TECHNICAL INFORMATION

Subject ► Modification of Terminal

For Models ► BDF460, BHP460, BLS712, BLS820, BTD120, BTD150, BTD200, BTW120, BTW150, BTW200, BTW201, DK2401, DK2403

Model: BTD120

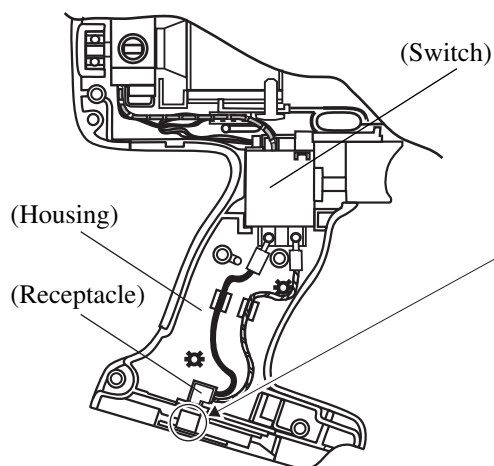
Description ► Terminal has been modified as illustrated below.

► **Current**	► **New**
10.0mm(3/8")	15.0mm(9/16")
1.5mm(1/16")	2.5mm(3/32")
Terminal (643955-2)	Terminal (643983-7)

Item No.	Current part		Q'ty	I/C	New part		Q'ty	Note
See below.	Terminal 643955-2		1	Yes	Terminal 643983-7		1
